PLANNING COMMISSION STAFF REPORT

DATE: November 19, 2014

SUBJECT: WEST COAST HOUSING PARTNERS ON BEHALF OF THE OWNER THE ERIC BRANDENBURG SEPARATE PROPERTY TRUST FOR APPROVAL OF A PLANNED DEVELOPMENT DISTRICT IN LIEU OF A CHANGE OF ZONE, A MAJOR ARCHITECTURAL APPLICATION, AND A TENTATIVE TRACT MAP FOR CONDOMINIUM PURPOSES FOR DEVELOPMENT OF 46 TWO-STORY, DETACHED RESIDENTIAL UNITS ON ROUGHLY 5.23 ACRES AT THE SOUTHEAST CORNER OF NORTH PALM CANYON DRIVE AND ALVARADO ROAD (CASE 5.1340 PDD 370 CUP, 3.3742 MAJ, TTM 36725) (ZONE C-1/RGA-6 / RESORT COMBINING ZONE). (APN's 504-074-001, 002 & 008) (KL)

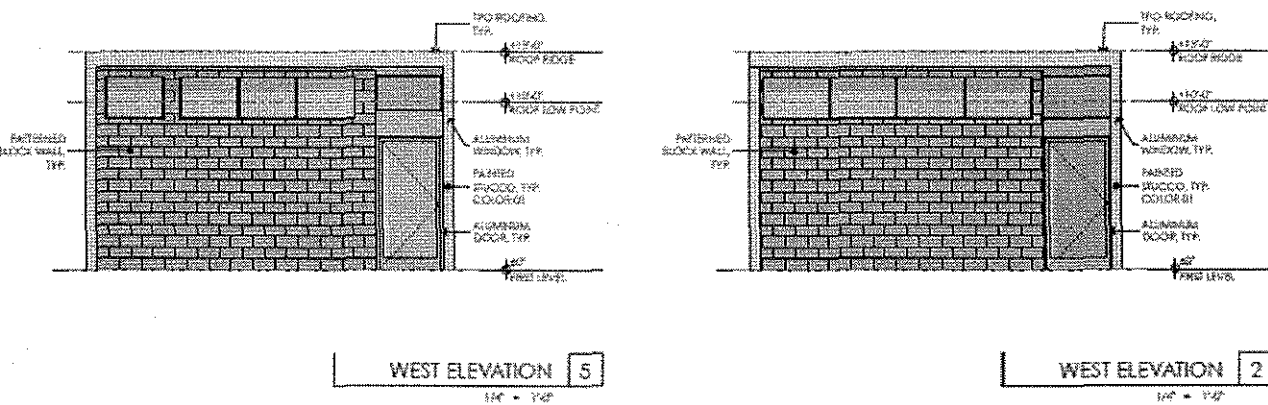
2. *Revise the site concept to provide better accommodation for pedestrian circulation within the project to provide sidewalks along one side of the streets or by other creative means, taking into consideration workmen and guests as well as residents. (Staff note: Reference PSZC 94.04 Architectural Review guideline D.1 which notes, "...Definition of pedestrian and vehicular areas; i.e. sidewalks as distinct from parking lot areas;" (e.g. vehicular travelways) and note additional PC comment #14 below on paving differentiation)*

Staff evaluation: Not resolved. The applicant has proposed changing the pavement of the private streets from asphalt to pre-cast brick pavers, however no accommodation for separation of pedestrian and vehicular circulation is proposed and no distinct pavement color or pattern is proposed to demarcate the pedestrian walkway from the vehicular travelway. A condition of approval has been proposed requiring either that separate sidewalks be provided, or the streets be revised to conform to the General Plan in terms of width with a provision that visual or physical delineation and separation of vehicular and pedestrian travelways be created within the project.
